Electric Power Generation, Transmission, and Distribution; Electrical Protective Equipment; Corrections

ACTION: Correcting amendments.

SUMMARY: On April 11, 2014 (79 FR 20316), the Occupational Safety and Health Administration published a final rule: Revising the general industry standards for electric power generation, transmission, and distribution work and for electrical protective equipment; revising the construction standard for electric power transmission and distribution work; and adopting a new construction standard for electrical protective equipment. The final rule updated those standards and made the general industry and construction standards consistent. This document corrects errors in the preamble and regulatory text of the final rule.

Table R–3—AC Live-Line Work Minimum Approach Distance

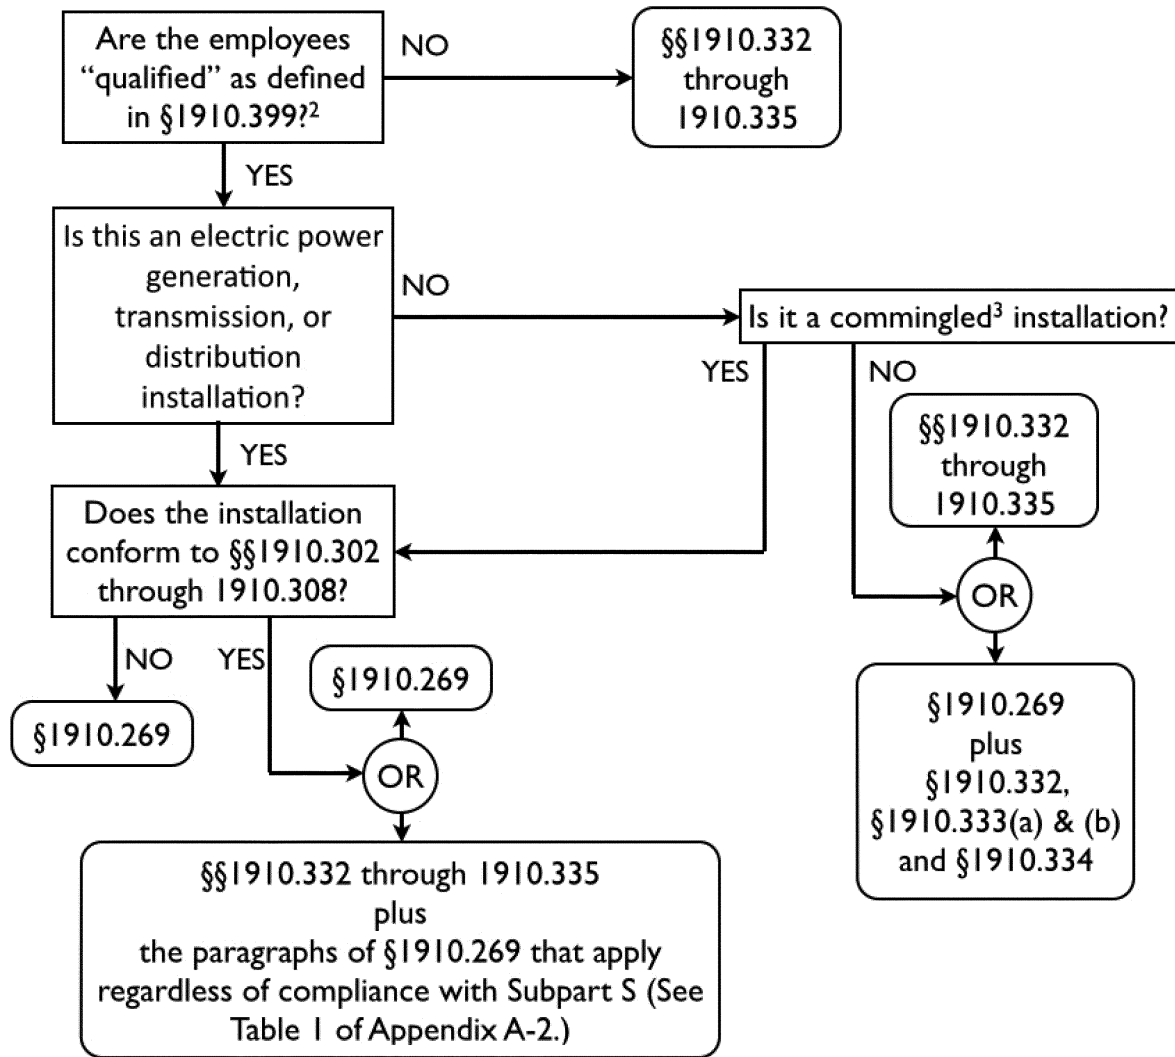
■ i. Under the entry “For phase-to-phase system voltages of more than 72.5 kV, nominal”, in the thirteenth row, revise the equation;

$$MAD = 0.3048(C + a)V_{L-G}TA + M$$
